SK-1/S02.306

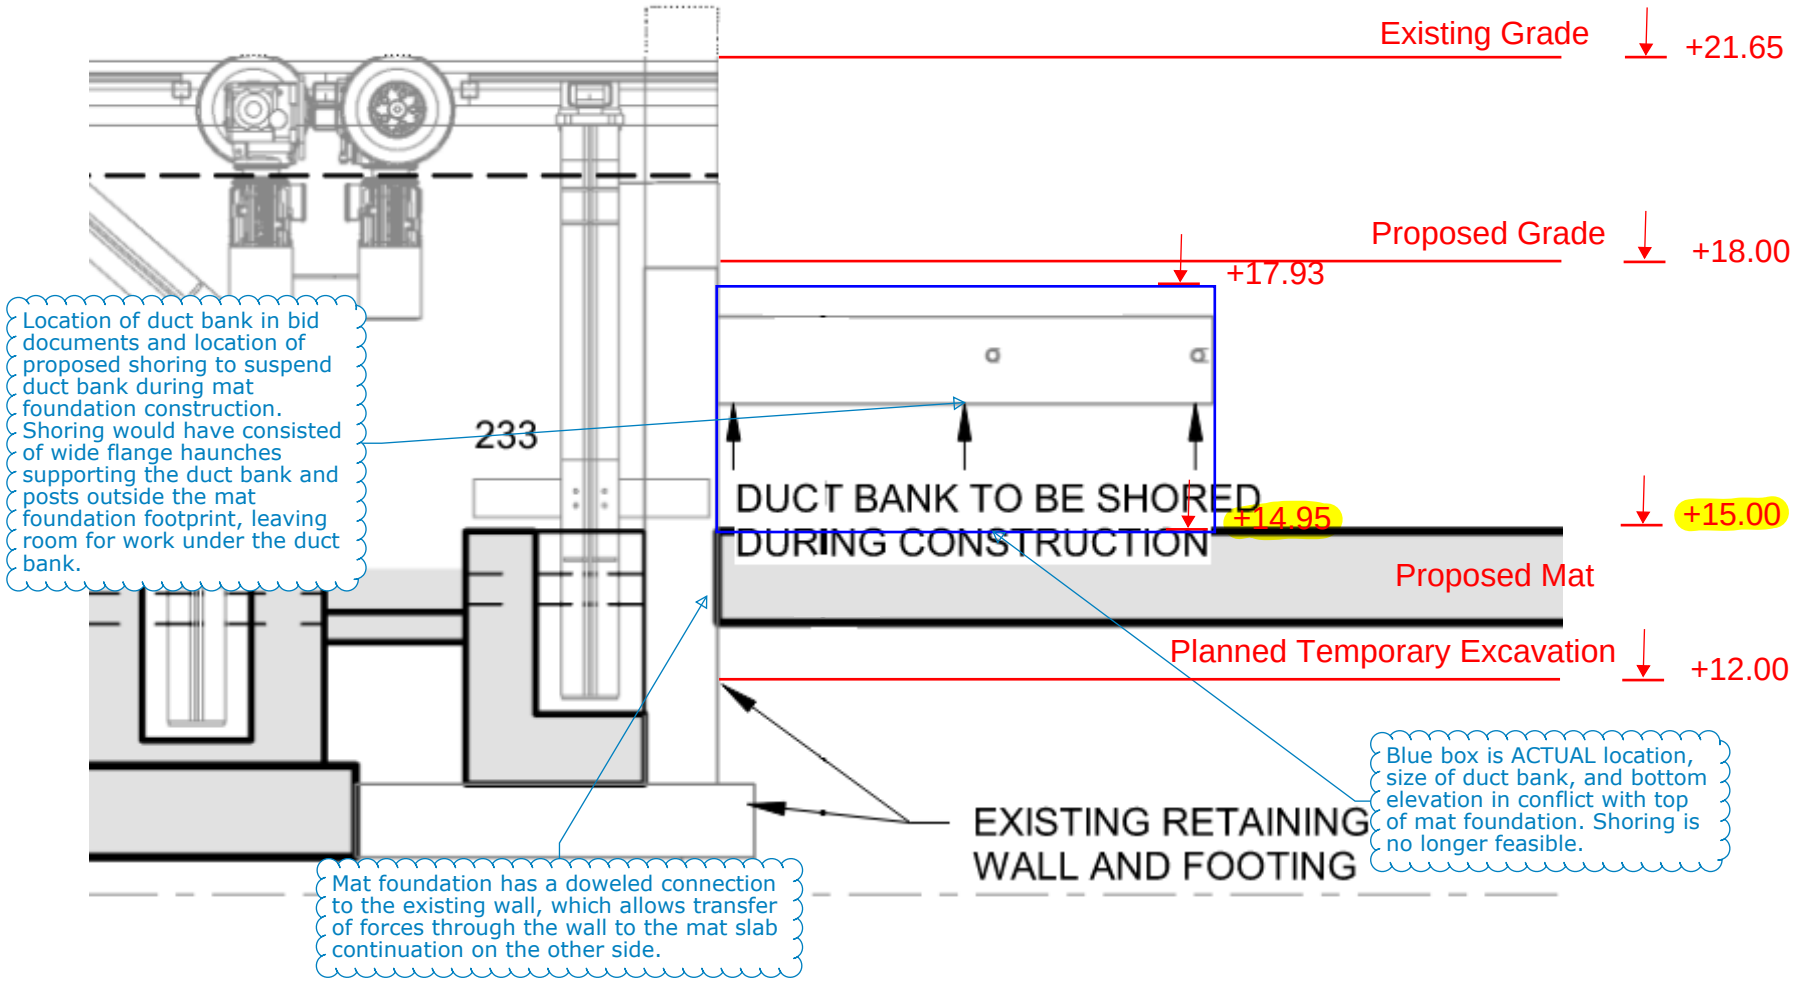
Existing Grade
+21.65
Proposed Grade
+18.00
+17.93
Location of duct bank in bid documents and location of proposed shoring to suspend duct bank during mat foundation construction. Shoring would have consisted of wide flange haunches supporting the duct bank and posts outside the mat foundation footprint, leaving room for work under the duct bank.
233
DUCT BANK TO BE SHORED DURING CONSTRUCTION
+14.95
+15.00
Proposed Mat
Planned Temporary Excavation
+12.00
Blue box is ACTUAL location, size of duct bank, and bottom elevation in conflict with top of mat foundation. Shoring is no longer feasible.
EXISTING RETAINING WALL AND FOOTING
Mat foundation has a doweled connection to the existing wall, which allows transfer of forces through the wall to the mat slab continuation on the other side.
